STAFF REPORT 06-14-2023 MEETING

APPLICATION NUMBER: 23-8392

ADDRESS: 1524-1550 BAGLEY (AKA 1530 BAGLEY)

SCOPE: ERECT MULTI-FAMILY BUILDING

Elevation view from applicant's submission materials, above. Perspective rendering, below.

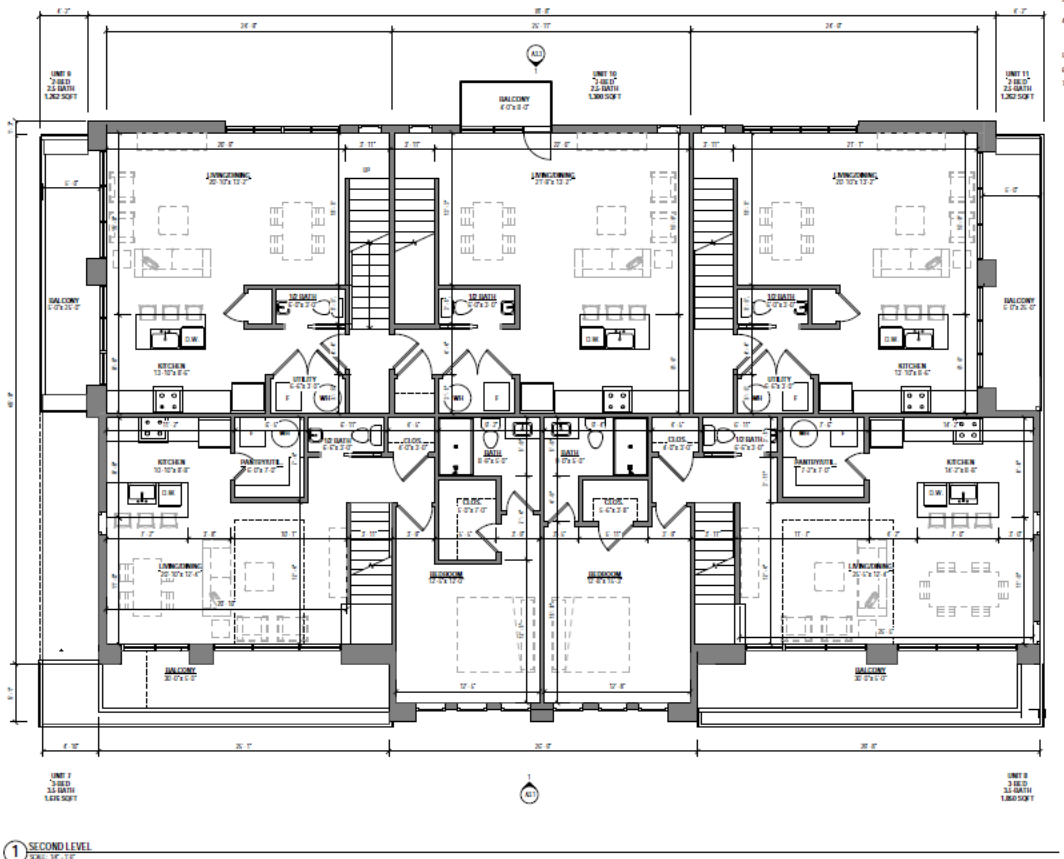
- Applicant: The front façade is generally equal in solid wall and openings
 - HDC Staff: Windows are not subdivided. In staff's opinion, a necessary level of detail and articulation is missing, and this Element is not met.

Proposed front elevation. Lack of subdivided windows create large areas of glass and a deficit of detail.

- HDC Staff: While the masonry texture is important, the building still exhibits a certain starkness and lack of texture. The only relief to the running brick bond are some soldier courses at the parapet and top floor lintels. Staff recommends incorporating some additional minor brick variation/courses as may be compatible with modern buildings of the type.

- HDC Staff: The building is very gray. Though neutral tones are a hallmark of contemporary architecture, some areas of accent color may be preferred in the otherwise colorful context of Corktown, and may help with Elements 8 (texture) and 19 (complexity).

- Additional detailing, which may include additional subdivision of windows, relief or variation in the brickwork, or other accents/complexity be added to the design. Such revisions are subject to staff approval.
- Landscape plan subject to staff review and approval be submitted

2nd floor plan from applicant's submission materials, above. Site plan, below.

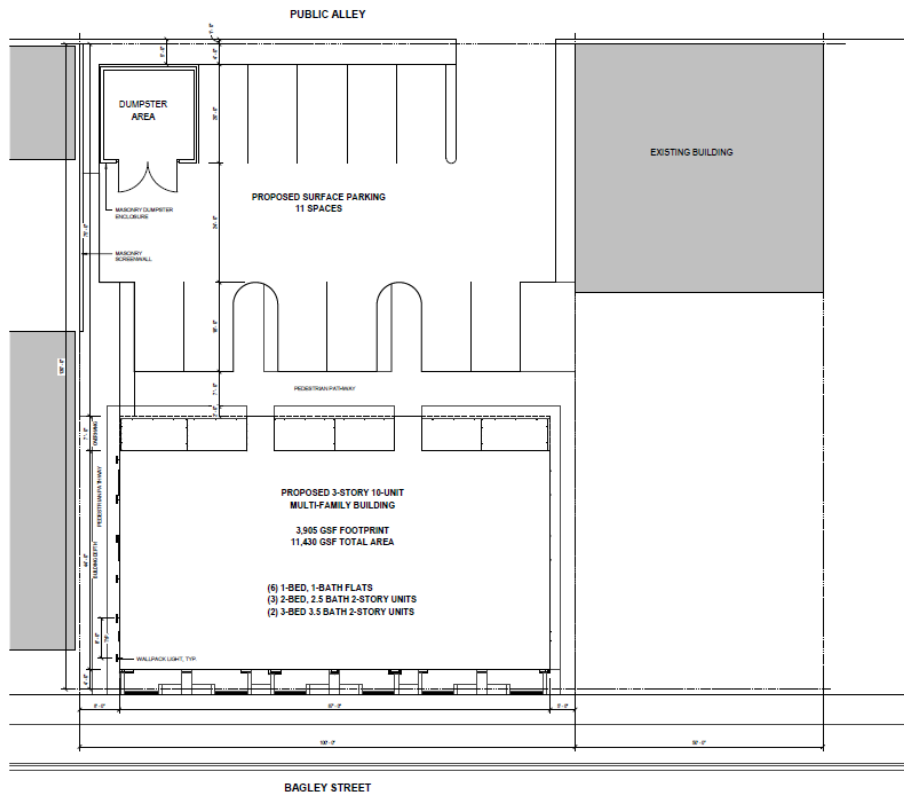
- HDC Staff: Though renderings appear to show some new trees and plantings, no site or landscape plan showing new plantings, or the buffer described above, has been received.
